STEREO TAPECORDER

TC-570

SUPPLEMENT

Subject: Power Amplifier Circuit Board Modification

Idling current adjustment
(Power amplifier circuit board)

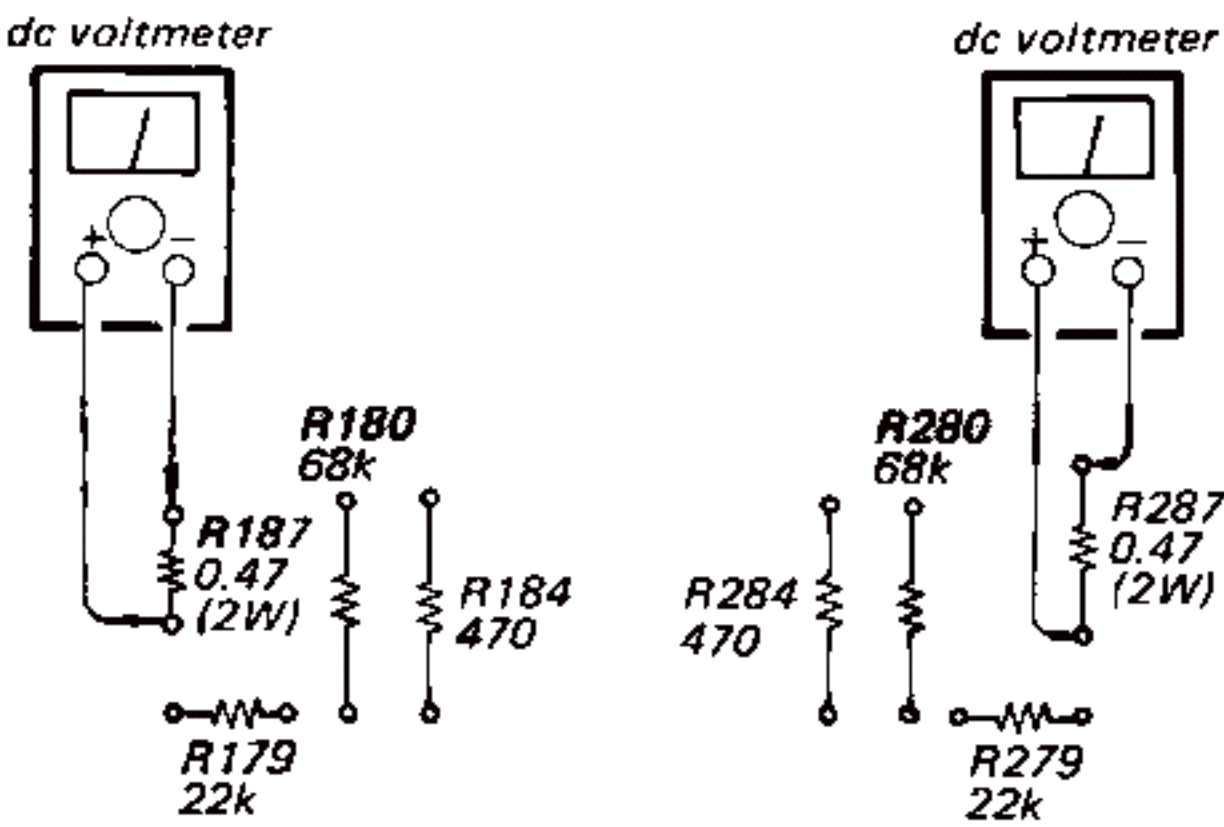
3. ELECTRICAL ADJUSTMENT
on page 17 (Service Manual Part No. 9-954-192-01).

14. Power Amp Idling Current Adjustment

1. Connect dc voltmeter to R187 and R287 in parallel.
2. Adjust R179 and R279 for 20 mV meter reading.
